Access Compliance Report

Public Rights-of-Way

Intersection ID: 45786	Main Street: LONG_HILL_DR	Cross Street: SHELLVIEW_LN	Location: S
ADA ID: 6C171CA5C62E	Ramp Type: BlendTrans1	Initial Pass/Fail: Fail	Overall Compliance: No
		Severity Score: 10

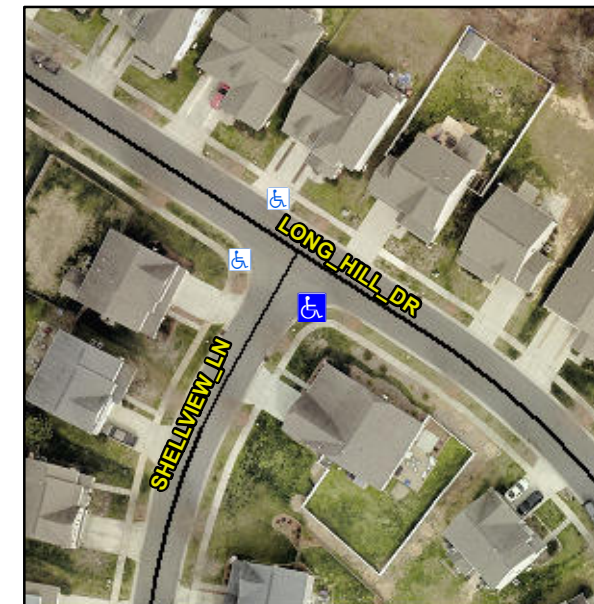
Not Found, R304.5.1, R304.5.3

Compliance	Description	Data	Compliance	Description	Data
N/A	Ramp Length (in)	70.0	Yes	BlendTrans Slope (%)	3.0
No	Ramp Width (in)	47.5	No	BlendTrans XSlope (%)	4.0
N/A	Flare Type LT	N/A	N/A	Flare Type RT	N/A
N/A	Flare Slope LT (%)	N/A	N/A	Flare Slope RT (%)	N/A
N/A	Flare Traversable LT?	N/A	N/A	Flare Traversable RT?	N/A
N/A	Landing Length (in)	N/A	N/A	DWS Provided?	N/A
N/A	Landing Width (in)	N/A	N/A	DWS Contrast?	N/A
N/A	Landing Slope (%)	N/A	N/A	DWS Length (in)	N/A
N/A	Landing X Slope (%)	N/A	N/A	DWS Full Width?	N/A
N/A	Landing Curb? (Y/N)	N/A	N/A	DWS Offset (in)	N/A
N/A	Shared Landing?	N/A			
N/A	Gutter Ponding?	N/A	N/A	Gutter Slope (%)	N/A
N/A	Gutter Lip Ht (in)	N/A	N/A	Gutter X Slope (%)	N/A
N/A	Painted X Walk1?	No	N/A	Painted X Walk2?	No
	X Walk 1 Direction	To NE		X Walk 2 Direction	To NW
	X Walk 1 Width (in)	N/A		X Walk 2 Width (in)	N/A
	X Walk 1 Slope (%)	1.0		X Walk 2 Slope (%)	4.4
	X Walk 1 X Slope (%)	2.7		X Walk 2 X Slope (%)	0.2

N/A	Ramp inside XWalk1?	N/A	N/A	Ramp inside XWalk2?	N/A
	Road Slope (%)	3.5		Clear Space?	N/A
	Road X Slope (%)	3.0	N/A	Clear Space to XWalk (in)	N/A
N/A	Any Obstructions?	N/A	N/A	Storm Grate/Utility Hazard?	N/A
	Obstruction Type			Storm Grate/Utility Type	
		N/A			N/A
			Yes	Surface Condition? (G/P)	Good
			No	Curb Slope (%)	20.6

Remove & Replace Curb Ramp With Two New Directional Ramps or Equivalent.
